New Plymouth District Council Plan Change Hearing Commissioners

S42A Report on Proposed Private Plan Change 49: Johnston Street, Waitara
Rezoning
Prepared for New Plymouth District Council

30 October 2020

SUBJECT: Proposed Private District Plan
Change 49 – Rezoning of land at
Johnston Street, Waitara from
Rural Environmental Area to
Residential A Environment Area
and Open Space B Environment
Area with specific provision for
subdivision and development of
110 lots.

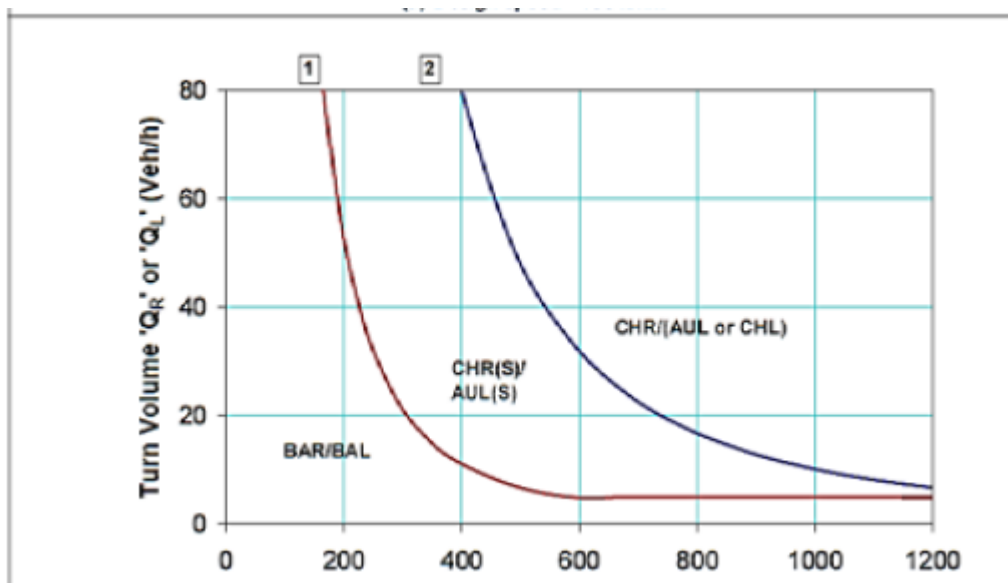
With regard to the Applicant's assessment of the form of the proposed new intersections (as set out in Section 10.3 and Table 10-1 of Appendix F1, I do not agree with this assessment for the proposed intersection. As a minimum a basic right turn treatment is required at each of the proposed intersections as specified in Figure 2.23 from Austroads part 6 (reproduced below).
